OOPS! WE GOOFED!

CORRECTED DRAWING FOR SBE LCBS-4
VOLUME 7, PAGE 31

FIGURE B.

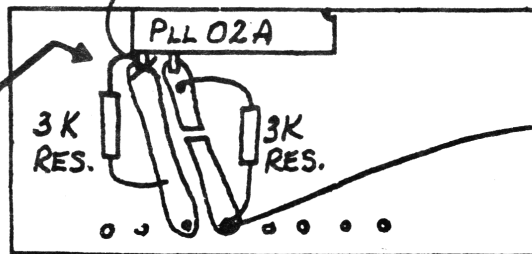
LIFT PIN 9 FROM P/C BOARD & SOLDER 3K RES. FROM PIN 9 TO P/C BOARD.

NOTE: USE CENTER OFF SWITCH
